**RE: BARANGAROO CONCEPT PLAN MODIFICATION (MP06_0162 MOD 8) AND
PROPOSED STATE ENVIRONMENTAL PLANNING POLICY AMENDMENT
(BARANGAROO) 2015**

Submission to
NSW Department of Planning & Environment

Concept Plan Modification
MP06_0162 MOD 8

Barangaroo

Figure 1 | Extract of Figure 27 from the DG's EAR (December 2010) – Indicative Height Comparison and Distribution cross the site

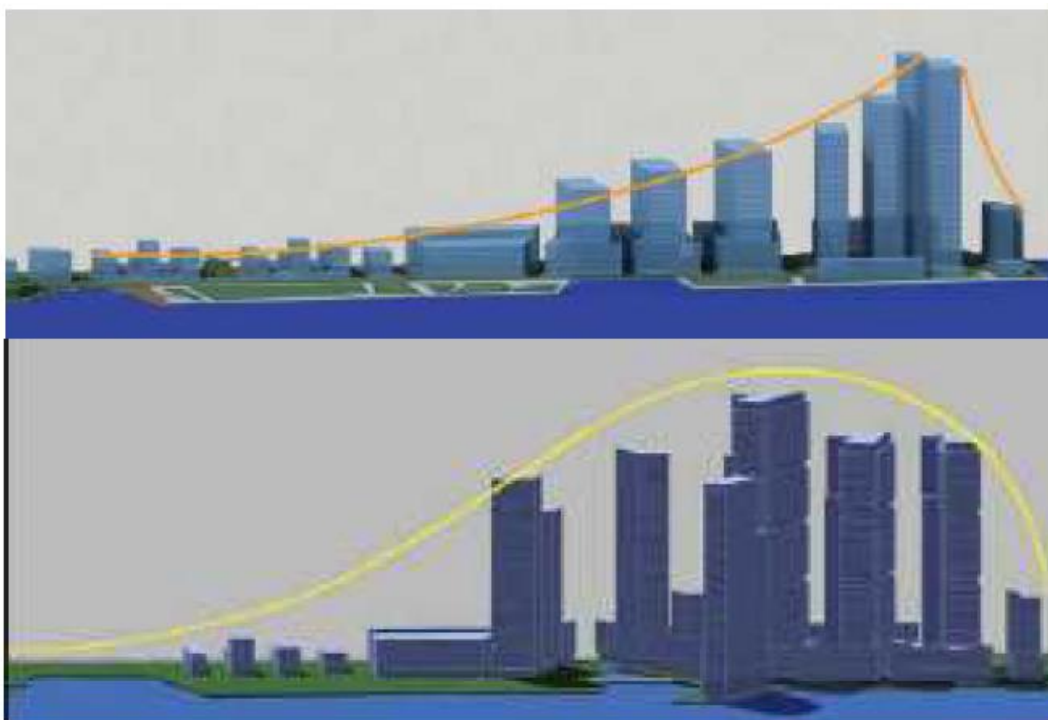
The DG's EAR concluded that the MOD 4 height was acceptable as the building heights were comparable to buildings within the CBD and less than the maximum building height allowed by the City in the CBD Core.

The Proponent has not provided an adequate planning justification as to why the original cited objectives in relation to the GFA and height should be abandoned, nor why should the established structure of the City, including the “fanning” principles from the City Core to its edges be ignored.

Figures 1 and 2 above illustrate that previous Concept Plan Approvals for Barangaroo South tapered building heights, moving from the southern end to the northern end of the Site. The consequence of this and the Proponent's key objective that buildings were to *be no taller than the CBD skyline*, meant that the Barangaroo development would not have a significant visual impact as a backdrop to the Opera House. Figure 3 above, illustrates the proposed transitions of heights under proposed MOD 8. Figure 3 shows that the original design principle of tapering buildings to the northern end of Barangaroo South has been ignored. The consequence is that Barangaroo is likely to impact on the setting of the Opera House.

Figure 3| Extract of Figure 19 from JBA EAR (15 March 2015) – Transition of heights through Barangaroo South

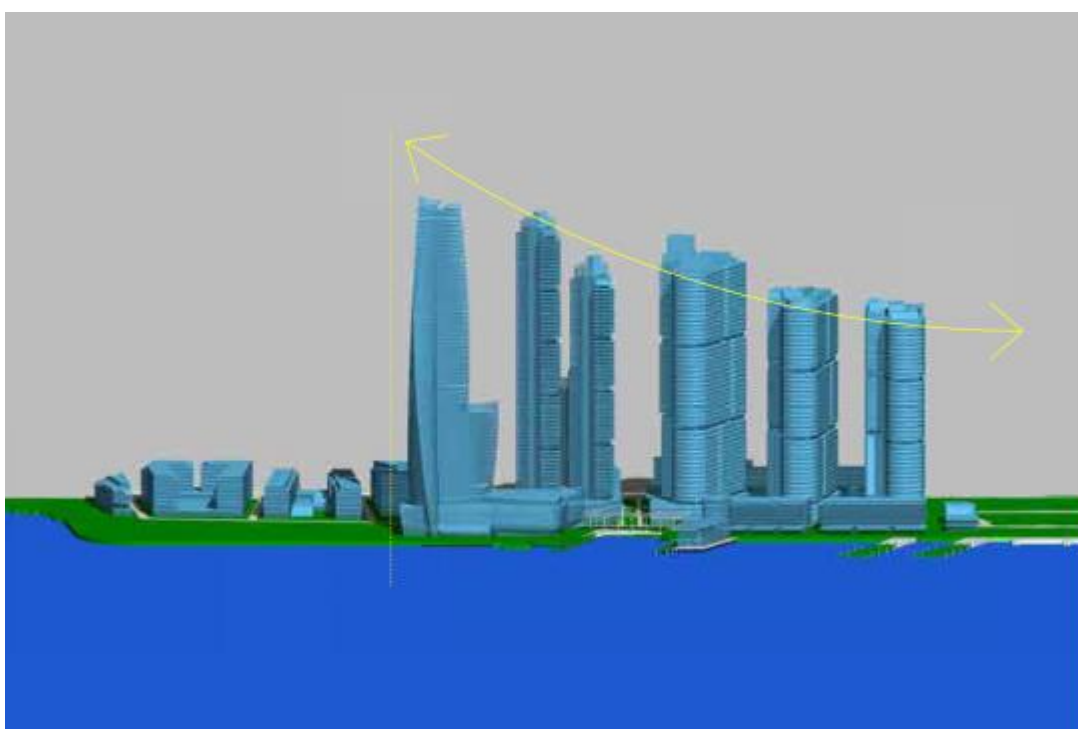
Leichhardt Council consider that the important transition in heights from north to south, that was fundamental to the original Concept Approvals at the Site, and while diminished by MOD 4, was still evident, but has been completely eroded by the current proposal (MOD 8), as illustrated in Figure 3 below.

If approved, MOD 8 will result in buildings at Barangaroo that are taller than the CBD skyline and therefore inconsistent with the original height objectives for the Site, which was considered by in the Director-General's Report, as appropriate.

The Proponent's justification to ignore the City's morphology in order to achieve the objectives of the Crown Hotel's brief and to achieve a landmark building are not sound planning reasons to so drastically change the visual impact of the City's skyline.
